MEMORANDUM

SUBJECT: The Grove staff review

The Grove at Shoal Creek

Figure 5.1: PUD Parks Plan Exhibit

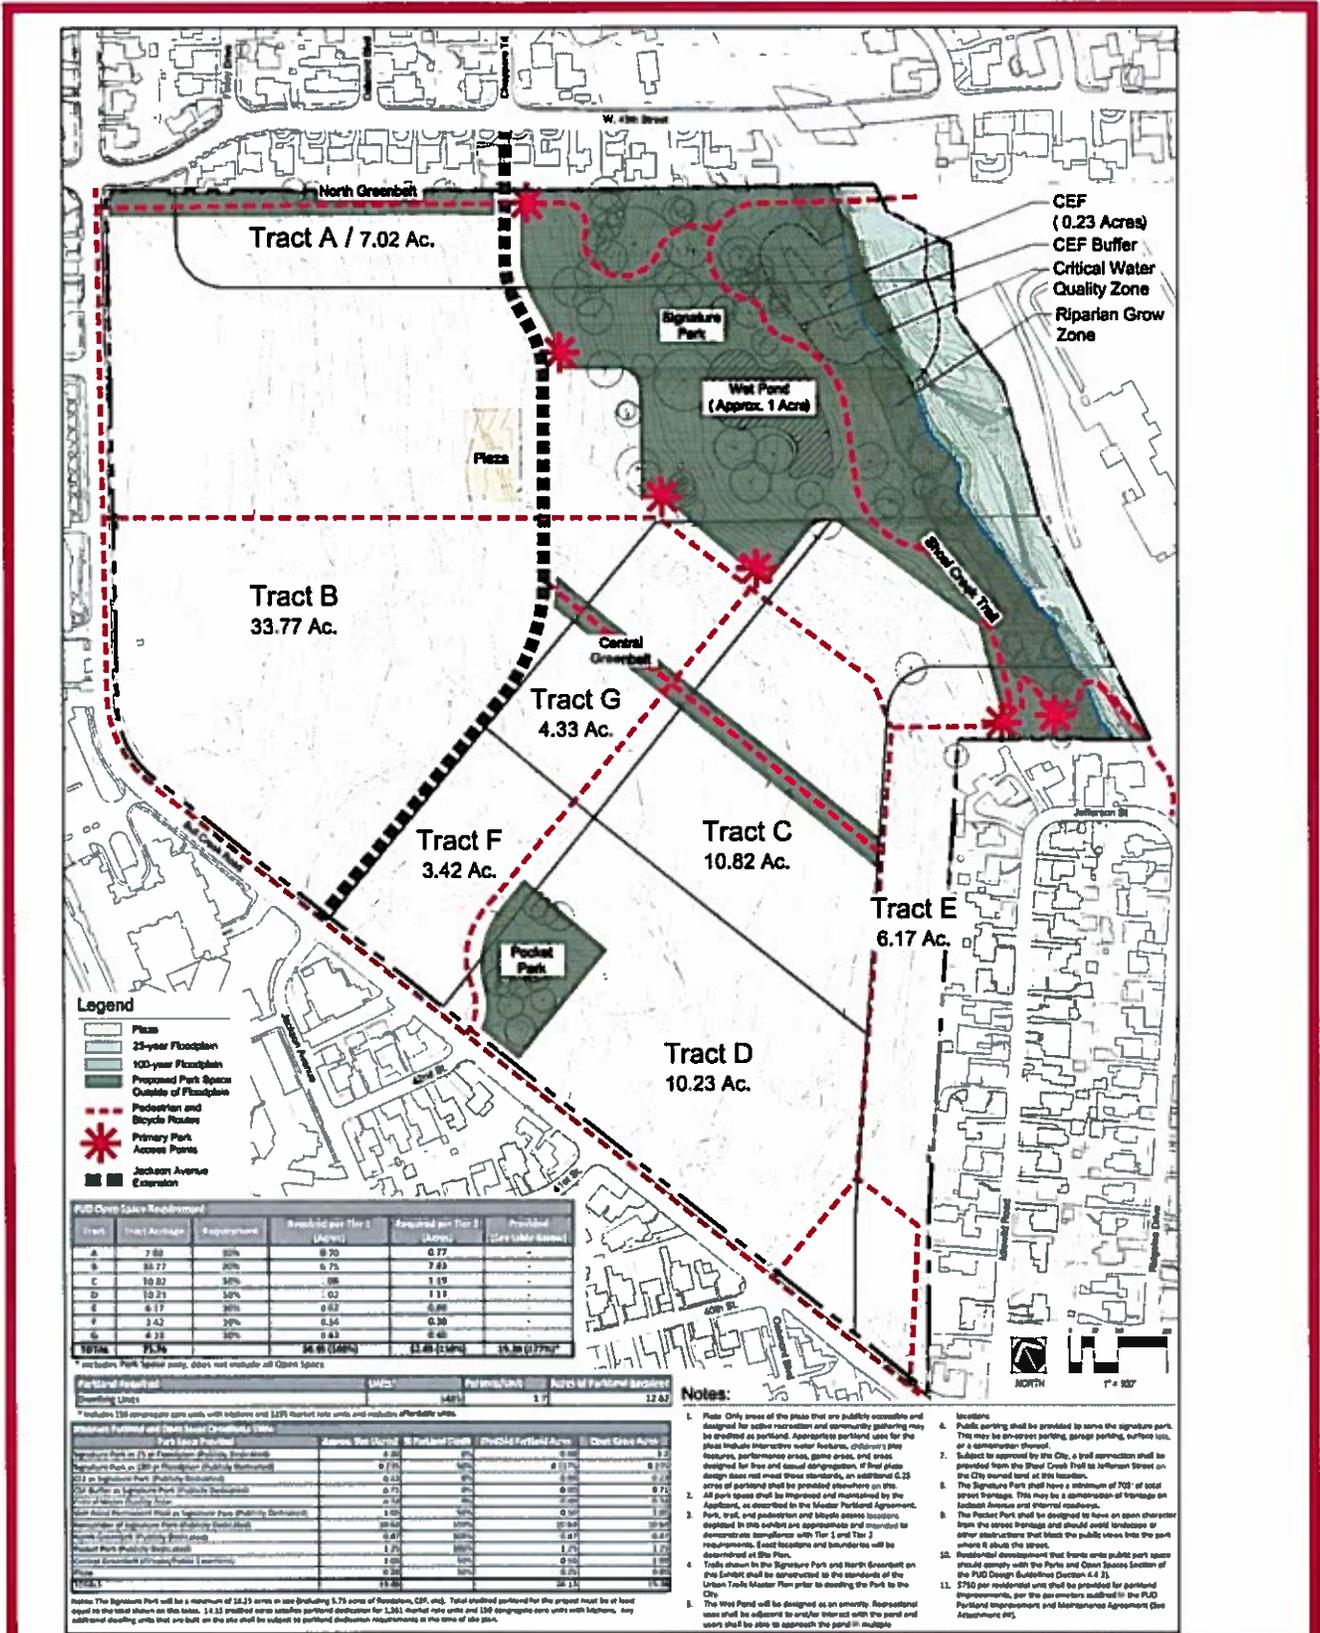
18. The Framework Plan on page 36 of the March 2016 document has been removed because it was redundant. *(Clarification)*
19. The PUD Parks Plan (Figure 5.1 on page 39) has been added to the document. *(Clarification)*

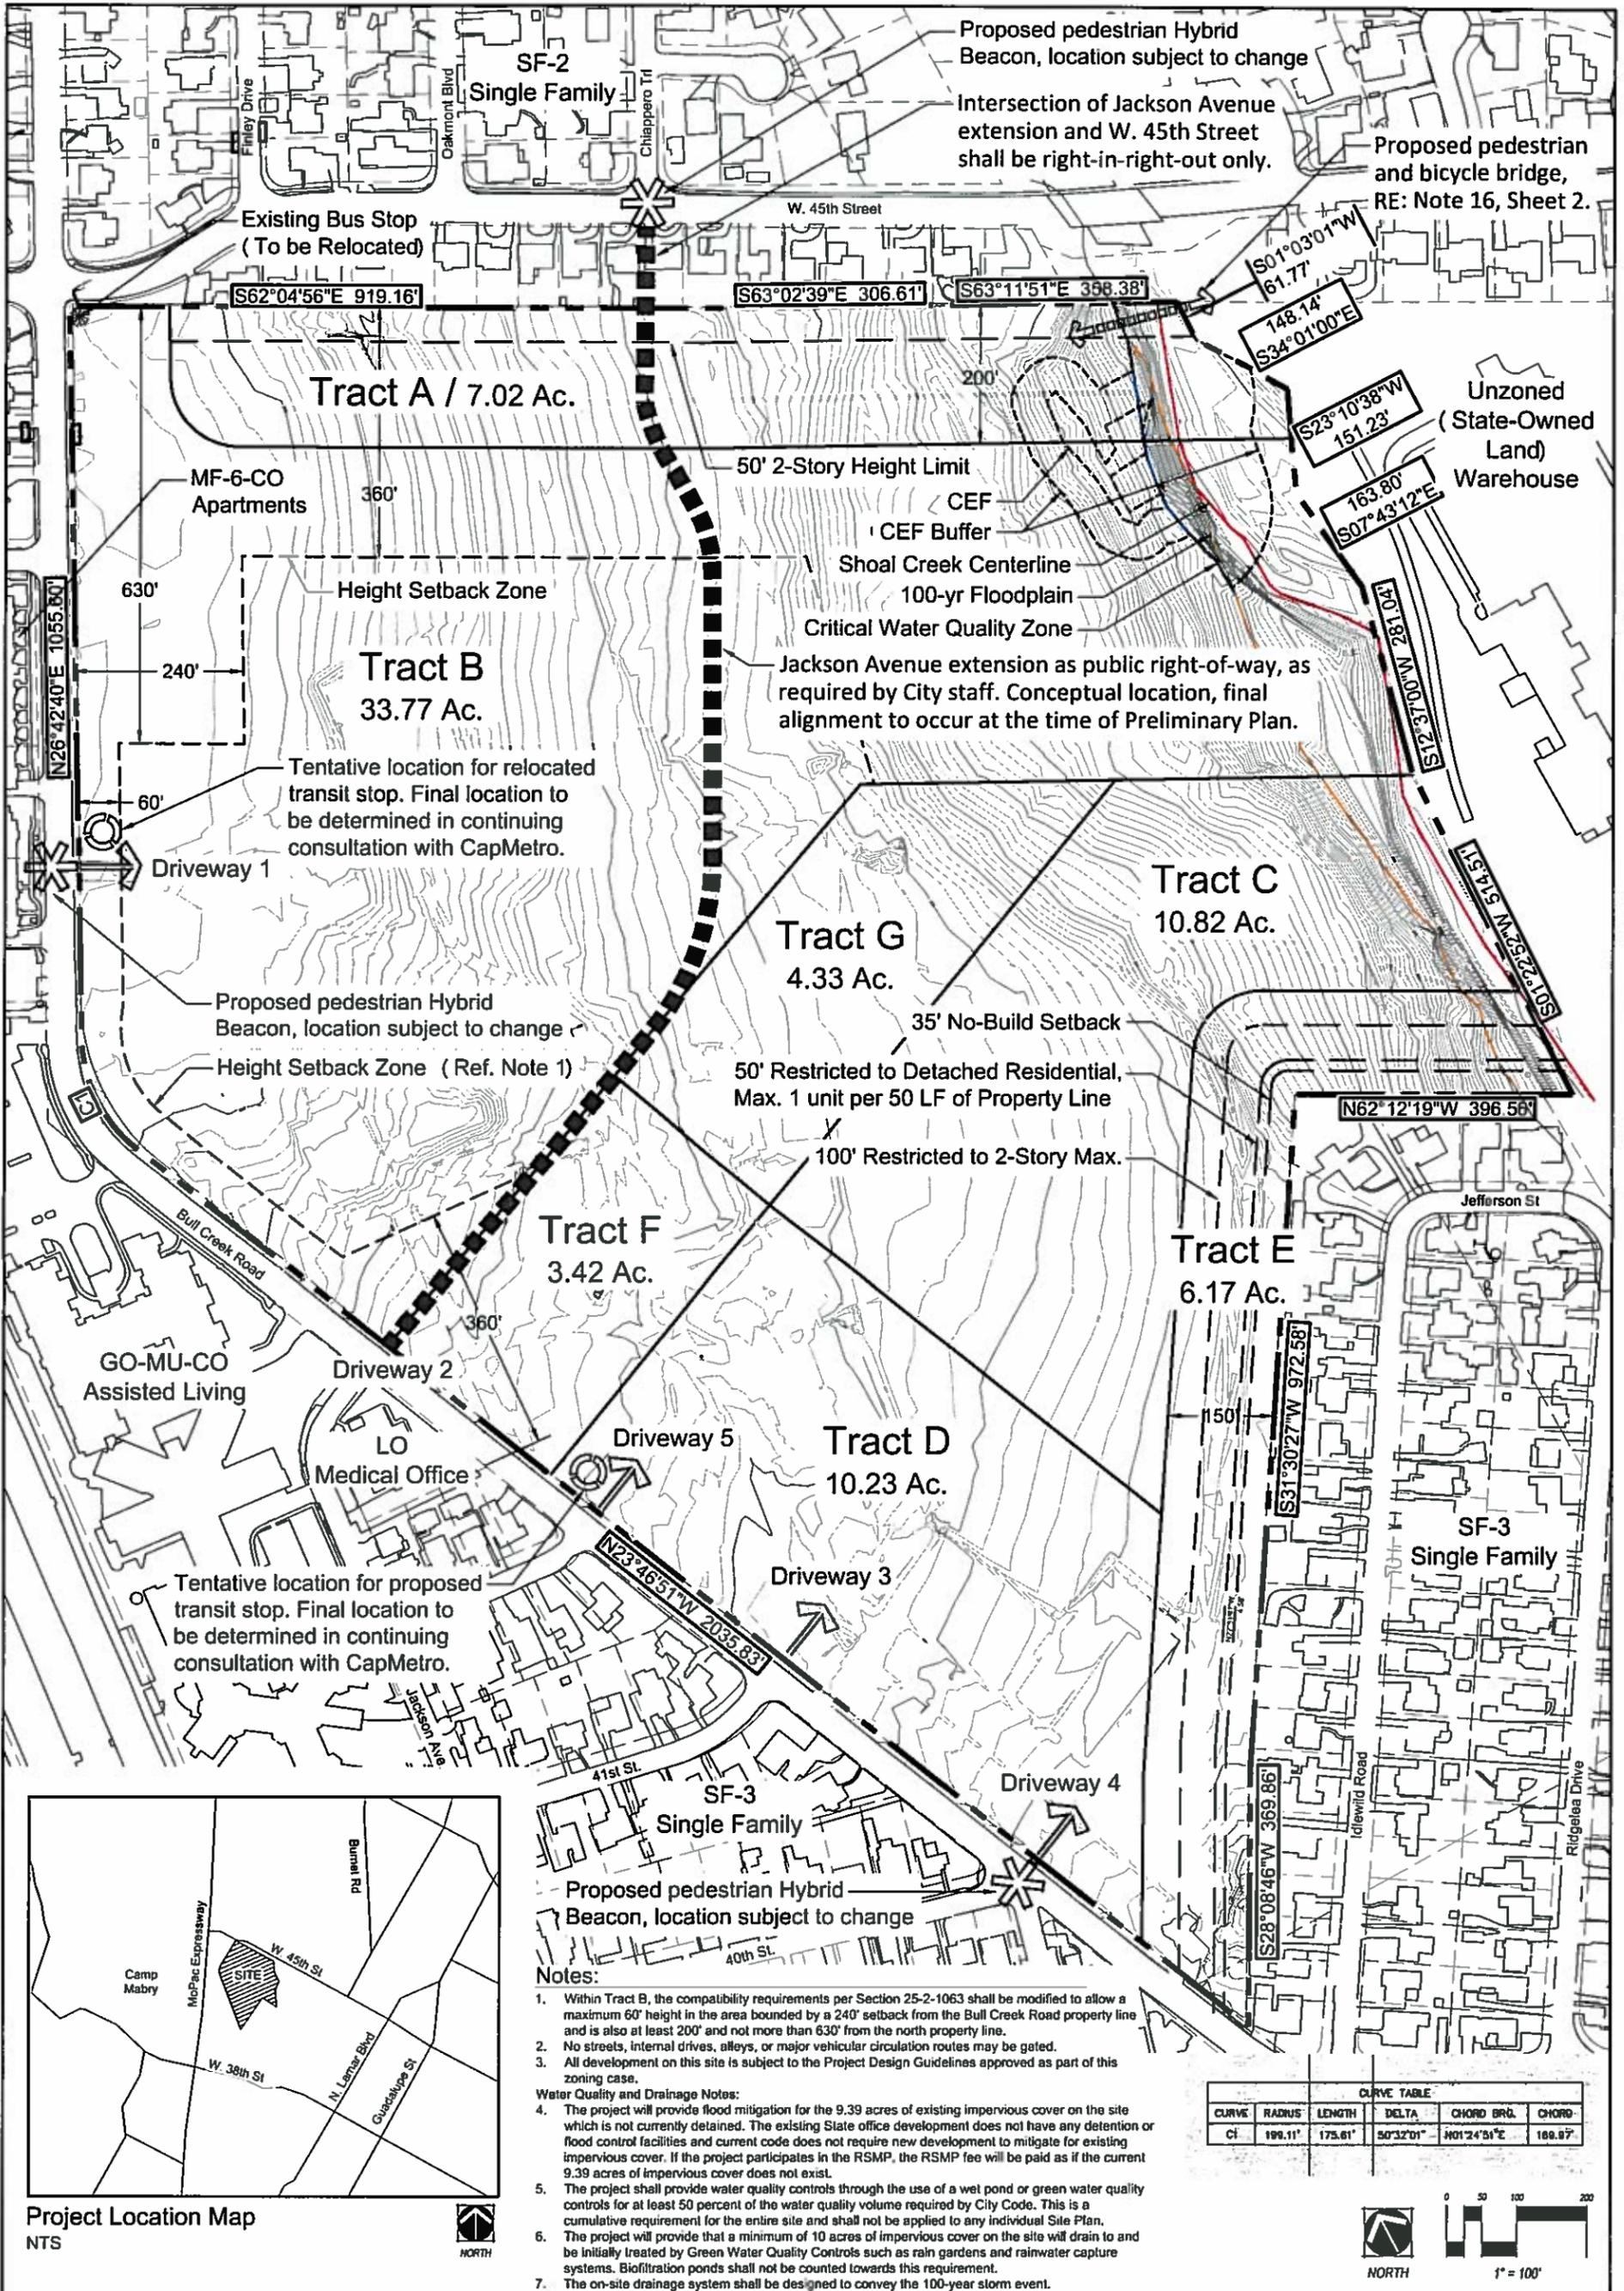
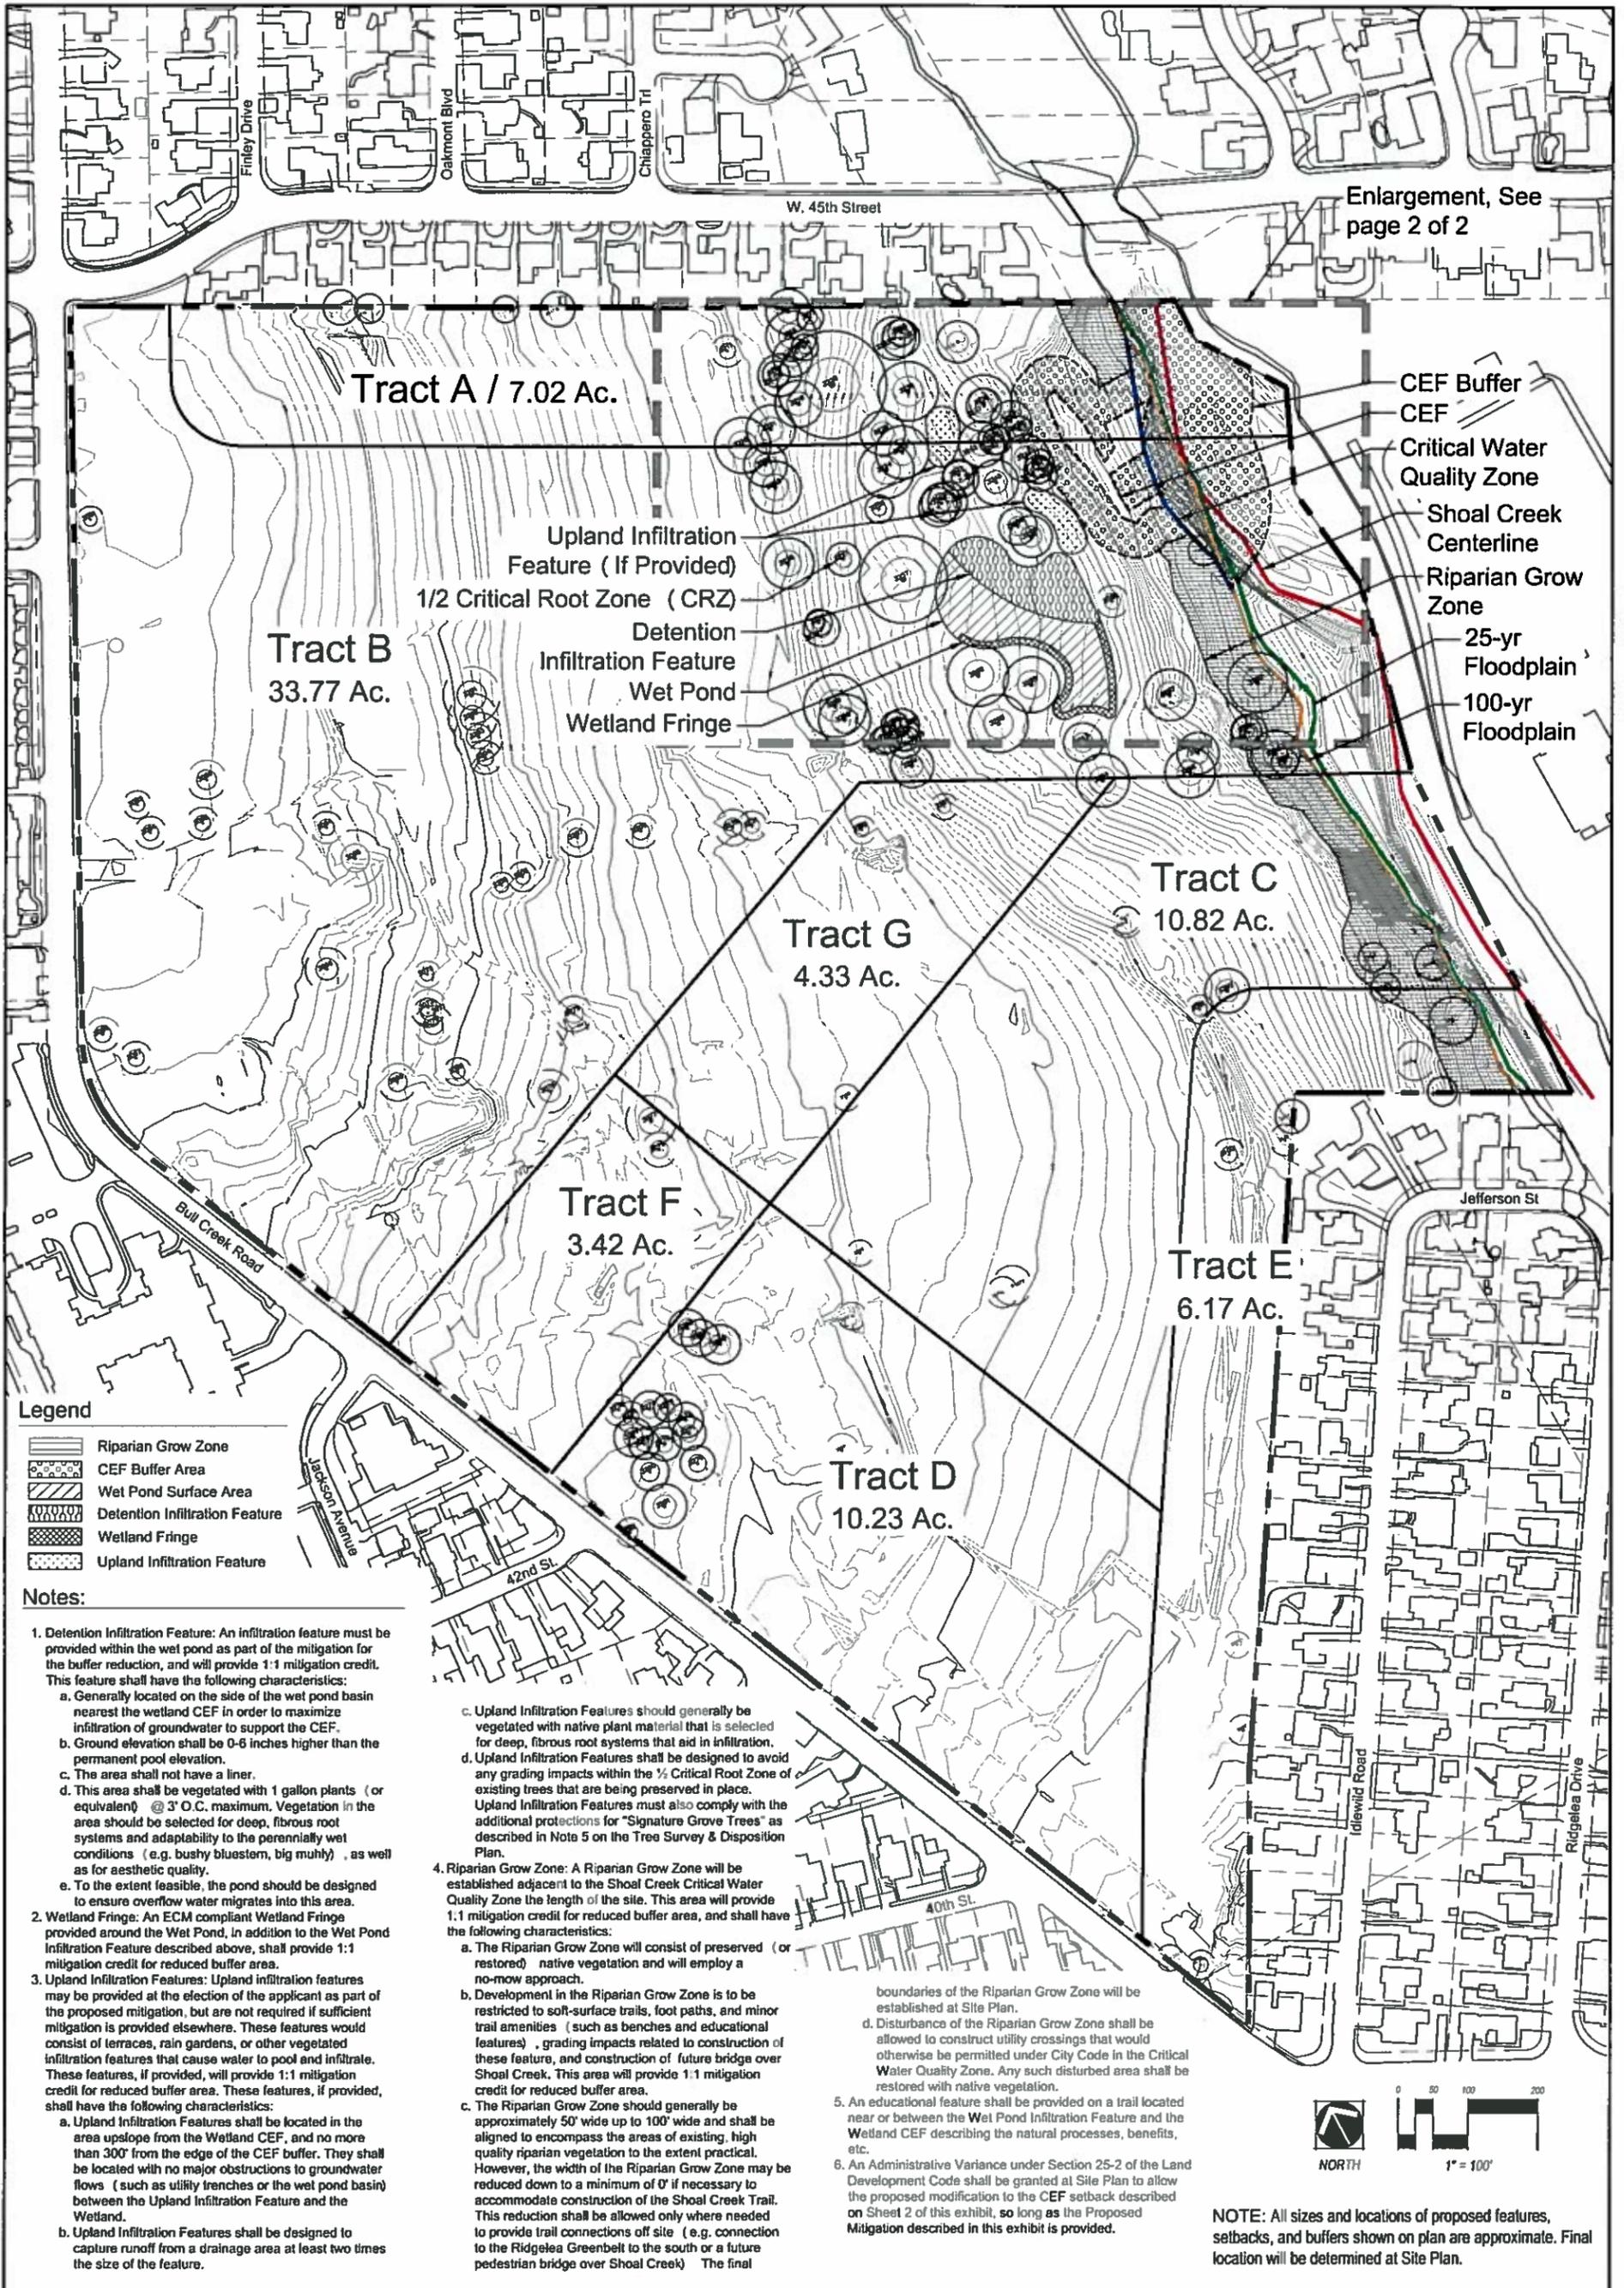
1. The proposed Jackson Avenue alignment has been graphically updated to reflect the most likely alignment. *(Clarification)*
2. The wording of note 6 on Sheet 1 has been updated to clarify that the Green Water Quality controls distributed on-site must provide initial treatment but each feature need not be sized to treat its entire drainage area (additional treatment would be provided later in sequence). *(Clarification)*
3. Note 7 was added on Sheet 1 to require that on-site drainage systems be designed to the 100-year storm. *(Commitment at Environmental Commission)*

9. Note 2 on Sheet 2 has been updated to clarify that residential units are capped at 1335 (not including affordable housing), that Congregate Care beds are capped at 300, and to define affordable housing. *(Staff Recommendation)*

10. Note 4 on Sheet 2 was updated to reduce the maximum office square footage to 210,000 SF. *(Staff Recommendation)*
11. Note 5 on Sheet 2 was updated to reduce the maximum retail square footage to 150,000 SF. *(Staff Recommendation)*

12. Note 16a on Sheet 2 was updated to clarify that the fiscal fees for the bridge may only be used by the City on bicycle and pedestrian improvements located east of the property in the event that the bridge cannot be constructed. *(ZAP Recommendation)*

13. Note 17b on Sheet 2 was updated to increase the required number of car-share parking spaces to 8. *(ZAP Recommendation)*
14. Note 18 was added to Sheet 2, which caps overall development on the site at 2.65 million square feet *(ZAP Recommendation)* and also includes the other staff conditions to their recommendation for PUD approval. *(Staff Recommendation)*

16. The Summary of Development Entitlements Table was added to Sheet 2 to provide a better reference point for the various entitlement caps agreed to as part of the PUD application. *(Clarification)*
